Report No. 10CFR21-0123
Rev. 0: 11/30/18
Rev. 1: 12/21/18

**10CFR21 REPORTING OF DEFECTS
AND NON-COMPLIANCE**

COMPONENT: EMD Fuel and Soakback Pumps – Potentially Undertorqued Cover Bolts

SYSTEM: Emergency Diesel Generator

Figure 1: Exploded View of Pump P/N 8410219

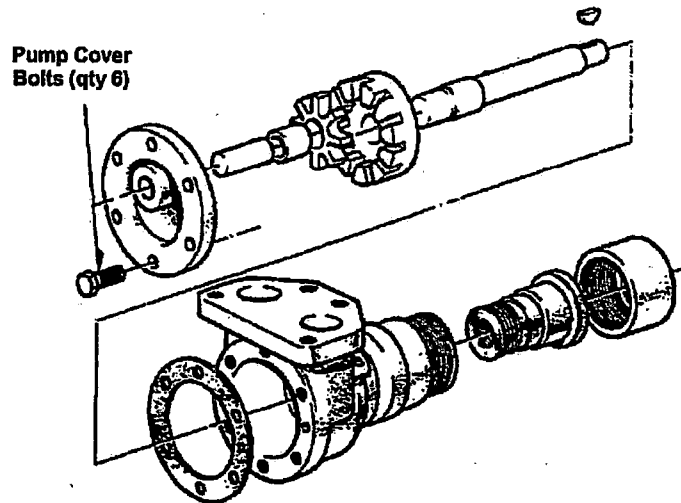
ESI was notified by a nuclear customer of two instances where a bolt was found loose or backed out of the cover of an EMD engine driven fuel pump P/N 8410219. Following notification, ESI inspected remaining pumps in inventory and found instances where one or more the pump cover bolts were loose or lightly torqued. See Figure 1 below for a visual depiction of the pump and bolts.

EMD fuel pump, P/N 8410219, is commonly used on all 12, 16, and 20-cylinder EMD model 645E4, E4B, and F4B engines. The pump is either mechanically driven from the engine (via the scavenging lube oil pump) or motor driven (as in the case of a backup/redundant fuel pump). The pump transfers fuel oil from the day tank to the fuel injectors to support fuel combustion. Without the supply of fuel oil, the diesel engine is unable to produce power which adversely affects the safety-related operation of the emergency diesel generator set.

ESI recommends inspecting the bolt tightness for all pumps. The recommended bolt torque is 108 to 120 in-lbs (12 to 13 Nm). After verifying bolt torque, a shaft freeness check is recommended. The pump shaft should be capable of being rotated by hand in either direction. Due to the small shaft size, this check is commonly performed with a small crescent wrench or with the coupling half installed on the shaft. Inability to rotate by hand indicates loss of end clearance and the pump should be returned to ESI for rework or replacement.

Note: For installed pumps where it is not possible to check shaft freeness, ESI recommends using a reduced bolt torque of 60 to 70 in-lbs (7 to 8 Nm). This is sufficient to ensure the bolts are snug while safeguarding against loss of end clearance that would otherwise go undetected.
